THE WATER HOUSE, MILLFIELD LANE, HIGHGATE

**REVIEW OF SUBMITTED CONSTRUCTION MANAGEMENT PLAN**

Prepared on behalf of the City of London

February 2015

"The Water House", Millfield Lane Swept Path Analysis 8.7m Rigid Vehicle Accessing Site

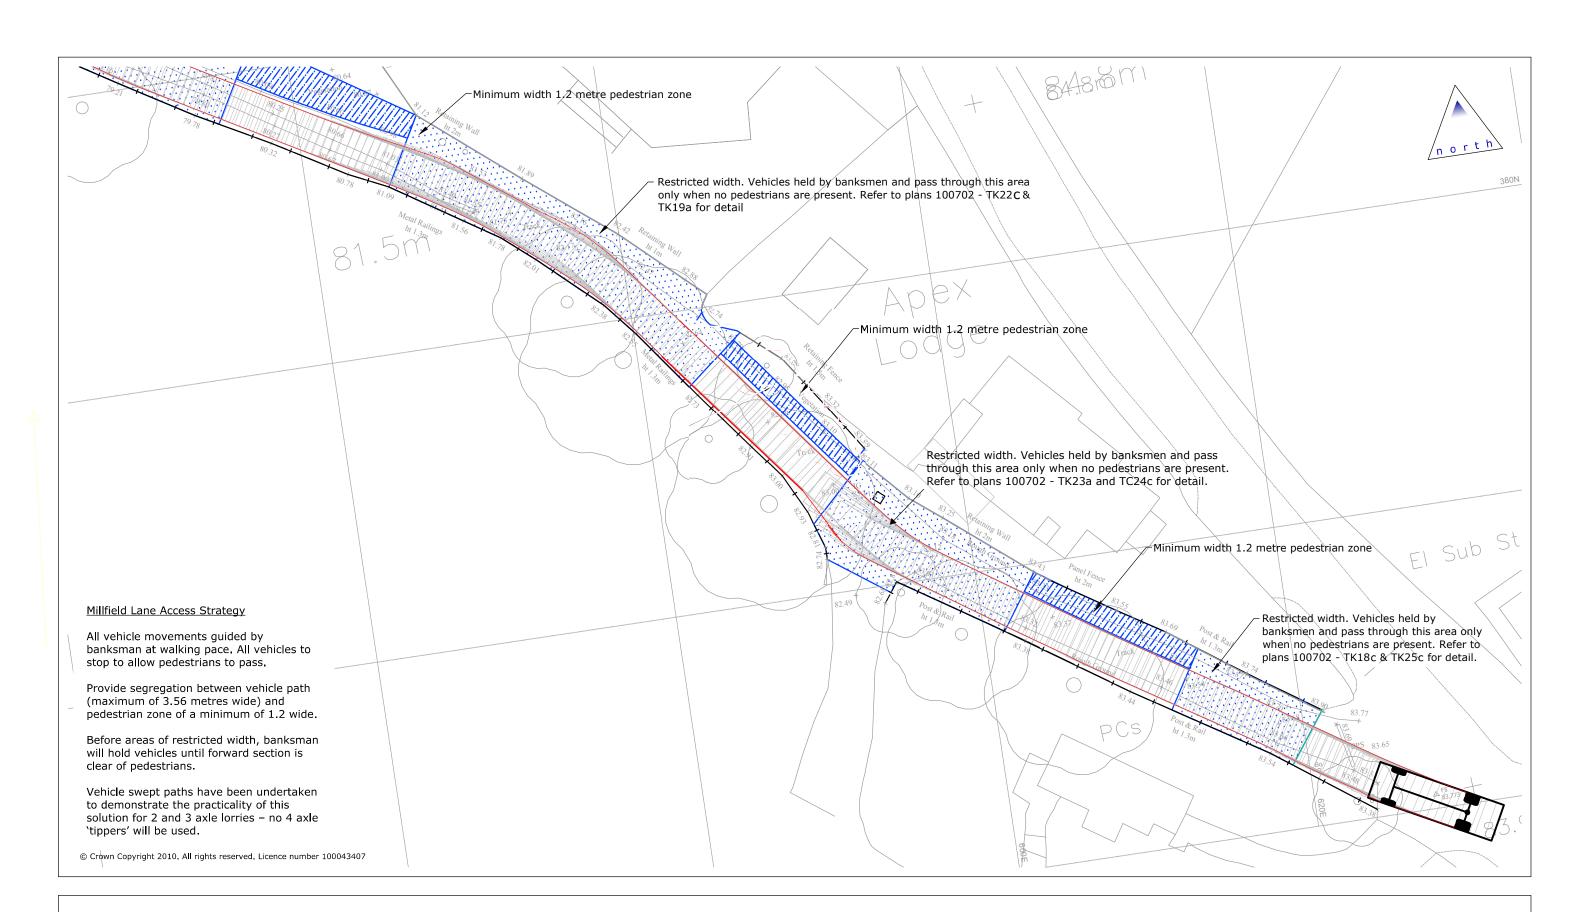
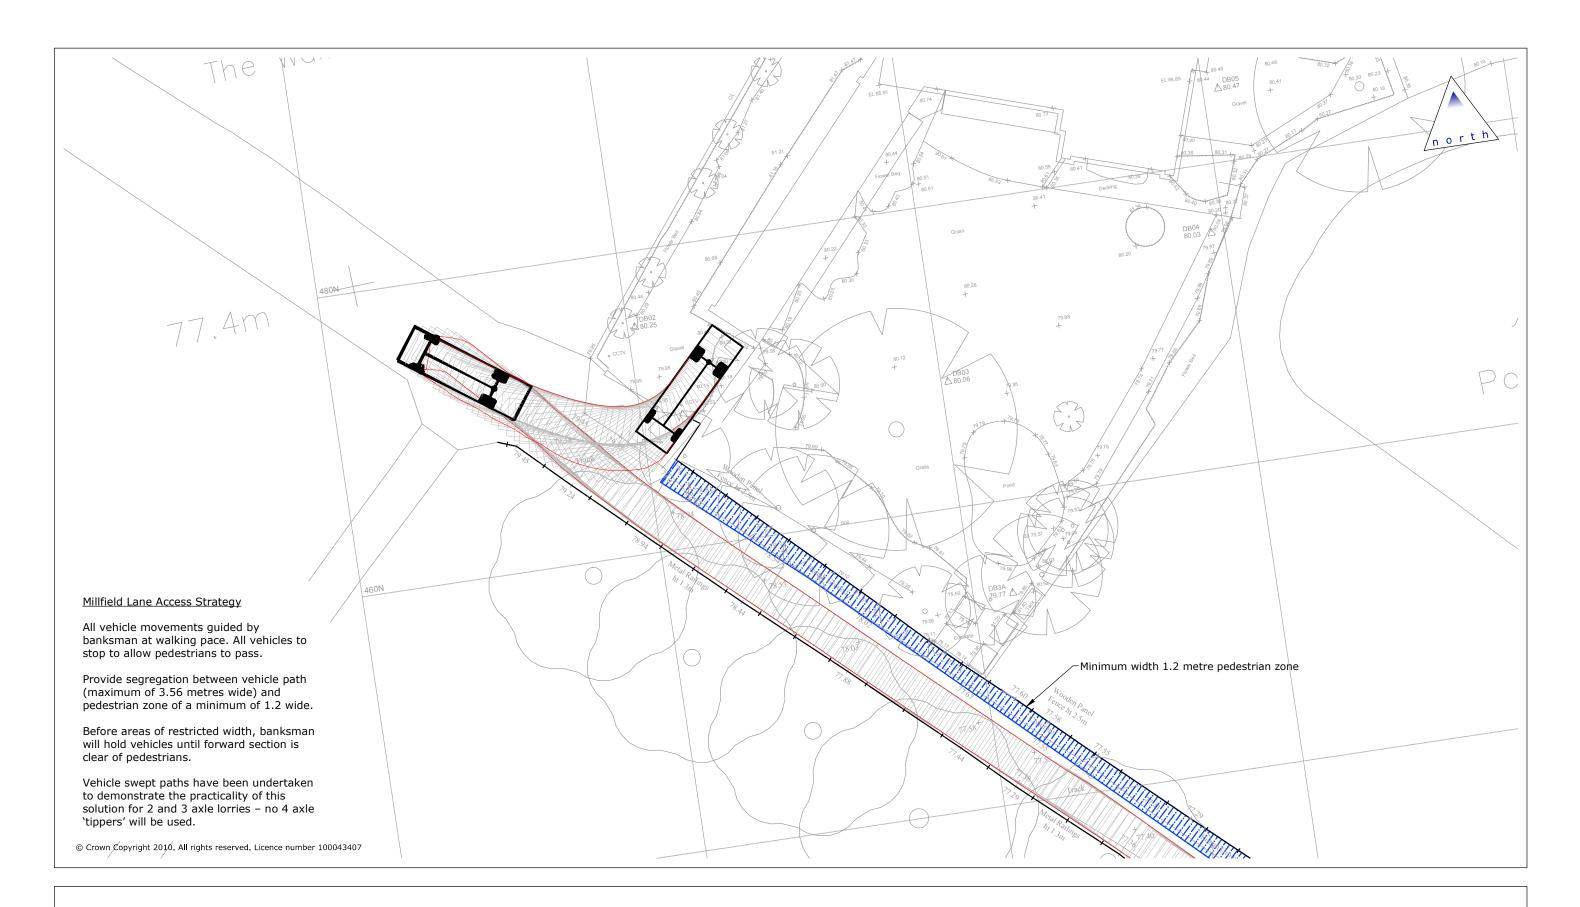
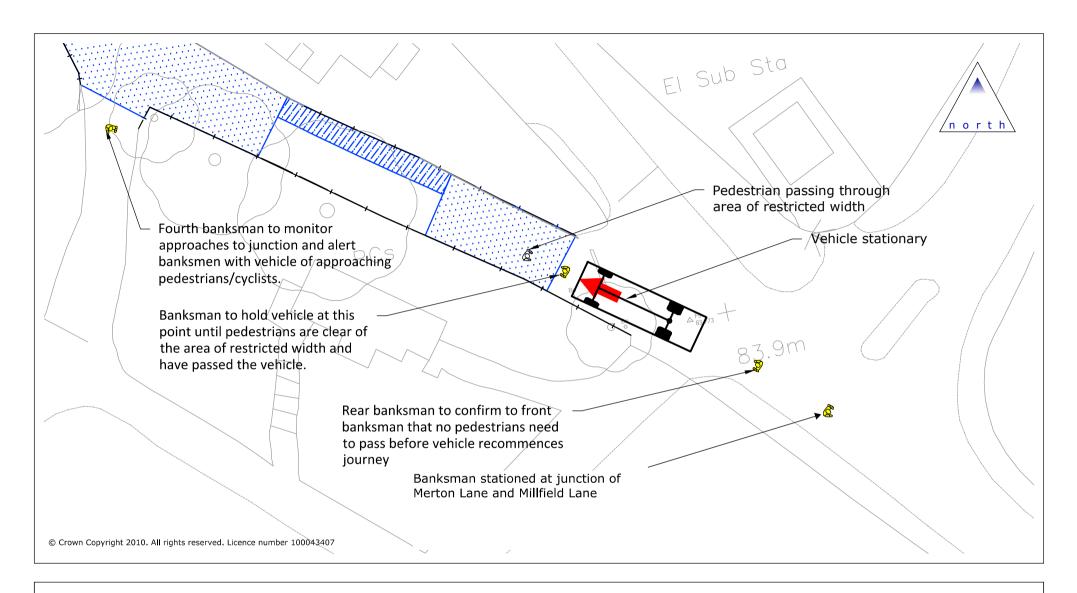
- 3.28 It is evident from the tracking plot illustrated on Plan 112/TK01 that there is very limited width within the useable Lane to allow for the safe passing of HGV's and other Lane users, particularly mobility impaired, parents with buggies or cyclists.

- 3.30 It also appears that the track plots submitted with the CMP illustrate the test vehicle running as close to the southern boundary / rail fence as possible in places. However, it is considered that, in practice, such an HGV would manoeuvre with a much greater buffer between the vehicle and the boundary than that illustrated on the submitted drawing and this needs to be considered by the Applicants through any subsequent vehicle assessments.

- 3.53 The remaining length of the Lane would not be able to provide this level of refuge with a significant proportion of the Lane being less than 3.5m resulting in less than 1m refuge / passing space, particularly so at the identified 'pinch points' on plan 112/TK01.

1	Status:	
	ISSUE	
	Drawn:	Checked:
	TG	PJC
	Drawing Number:	Date:
	112/01	Nov 2014
	Revision:	Scale
	-	1:1000@A3

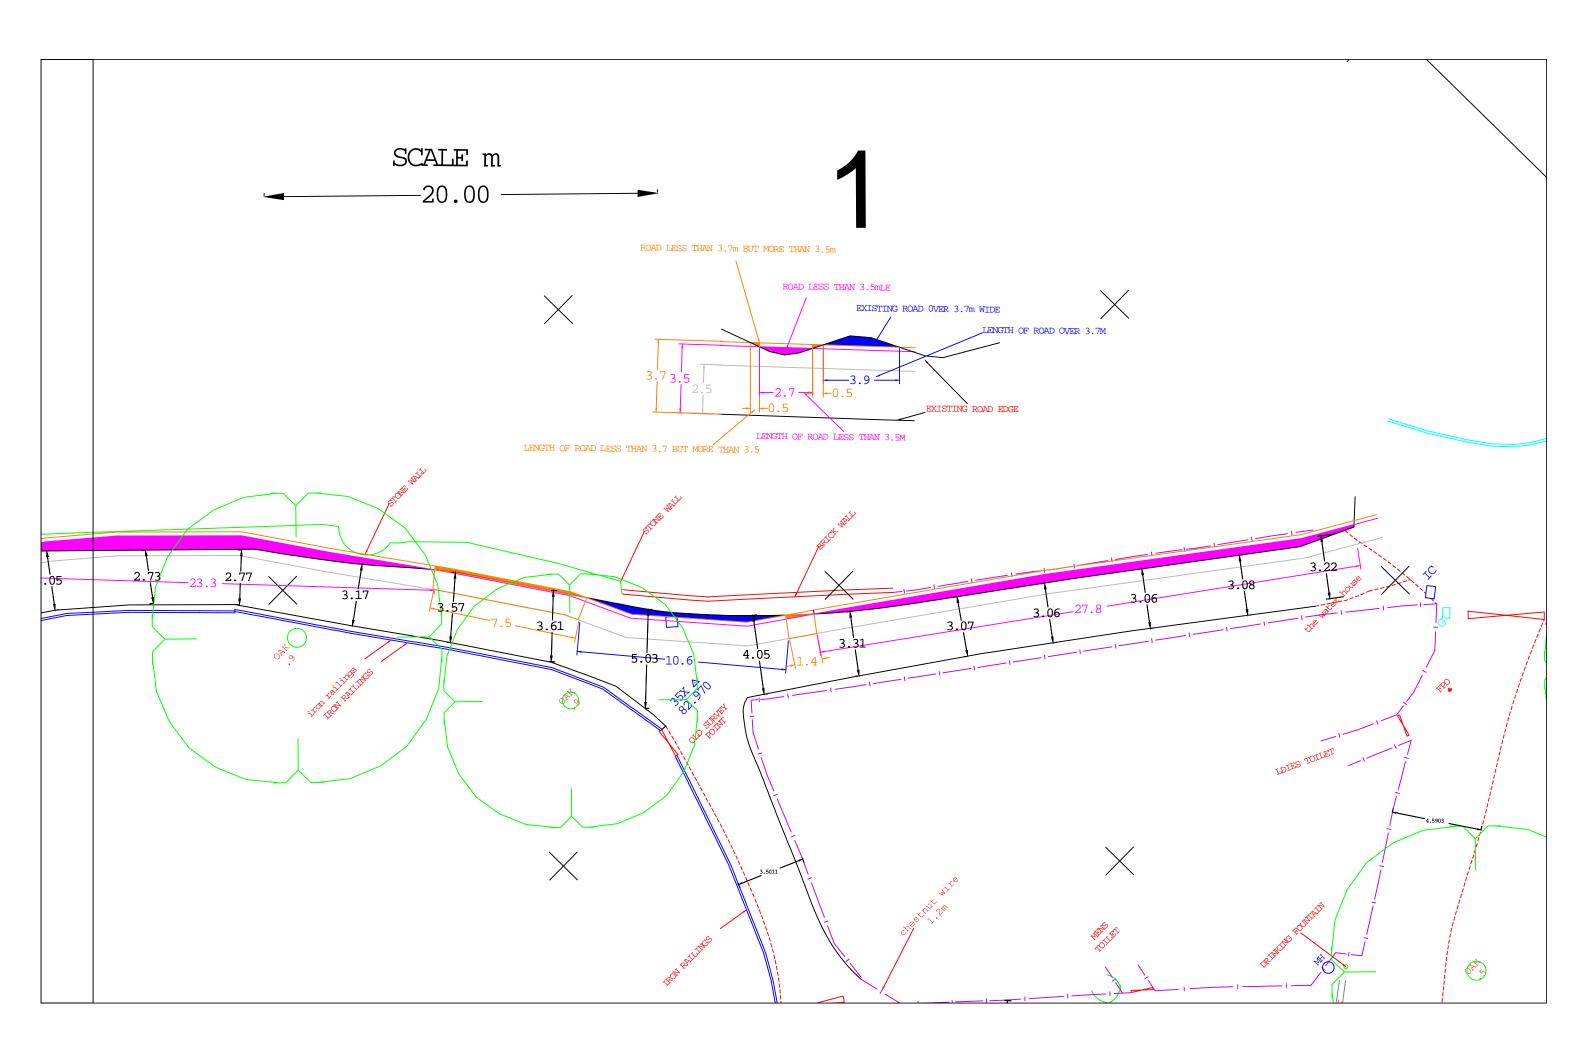
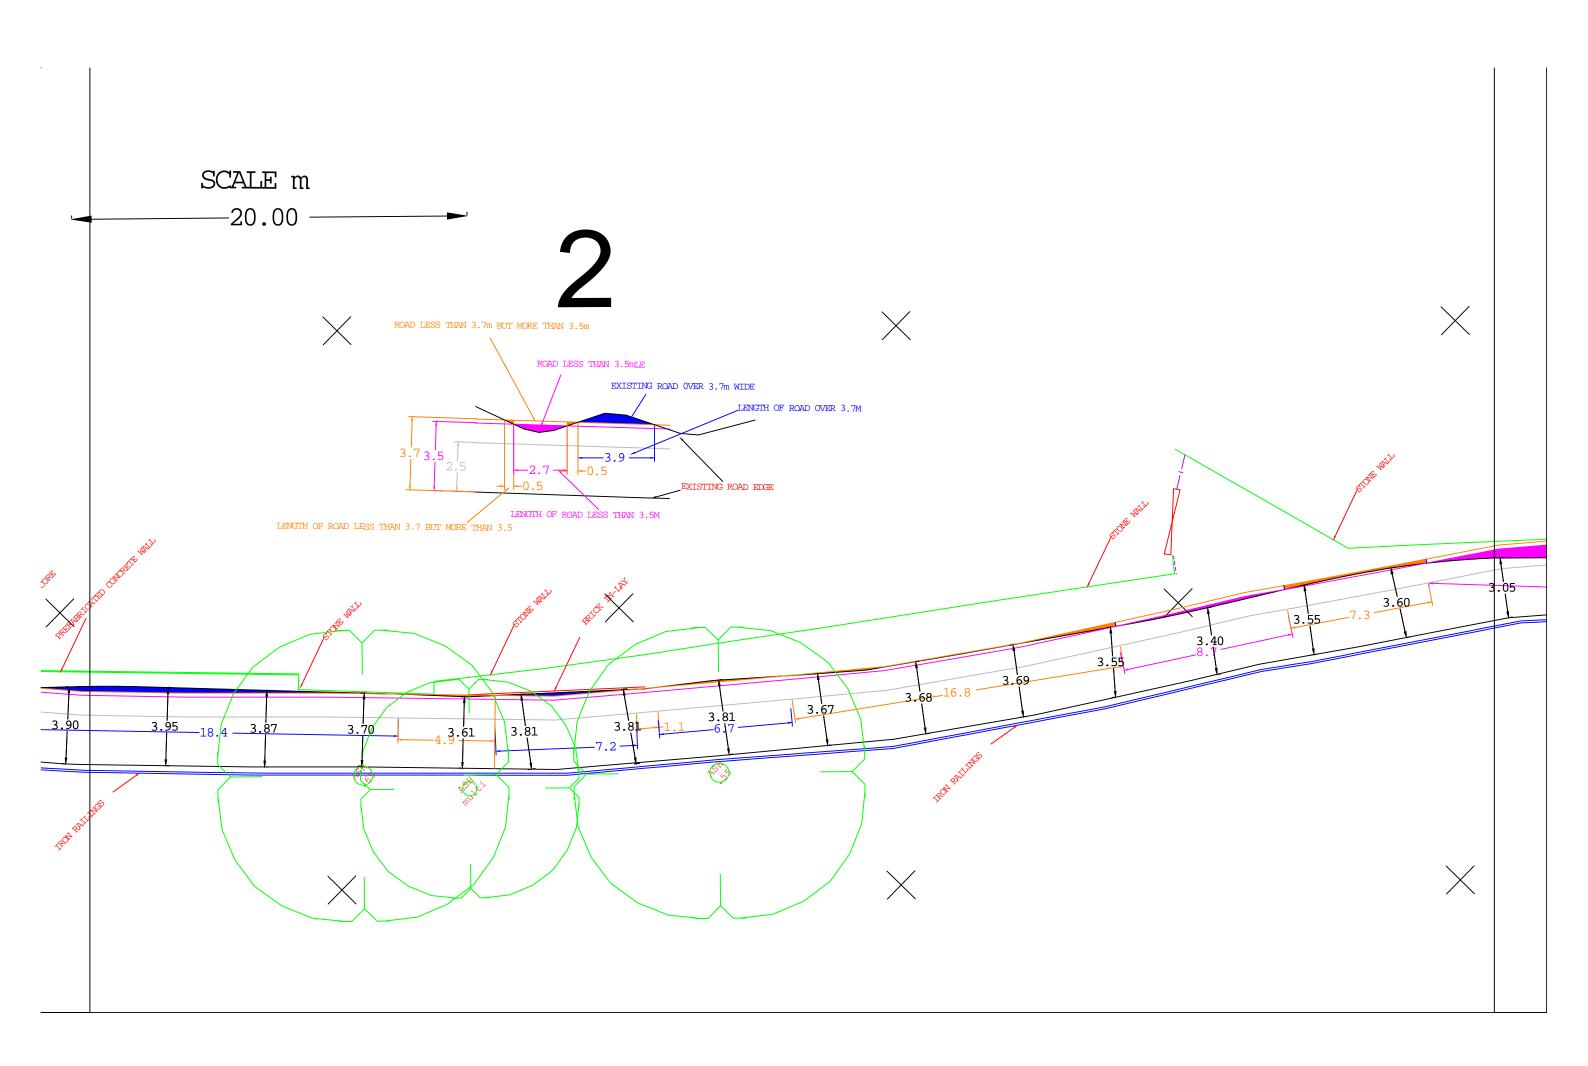
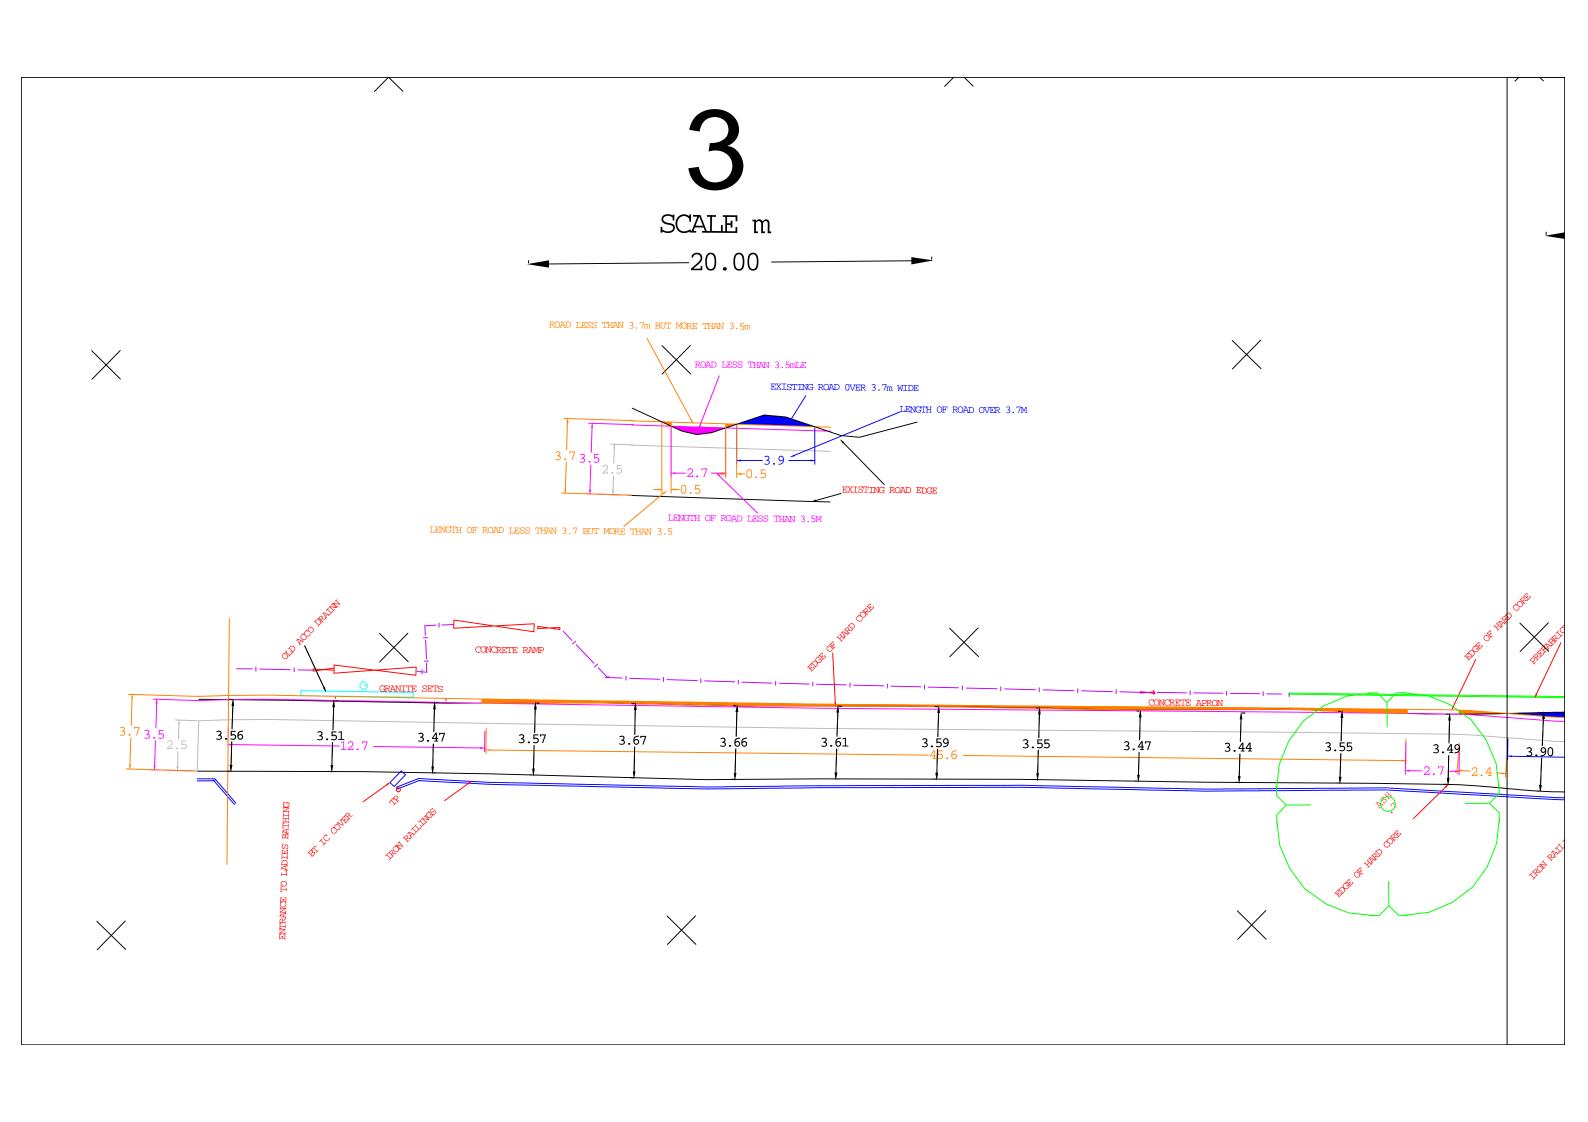
- 2.9 Millfield Lane exhibits a range of surface conditions but generally appears to be an unbound, worn surface with a run of concrete through much of the length. There is evidence of wear, rutting and ponding on the Lane with the surface appearing susceptible to degradation in respect to environmental conditions and existing levels use. A photographic inventory illustrating the general nature of the Lane and its surface condition is provided on attached plan 112/001.
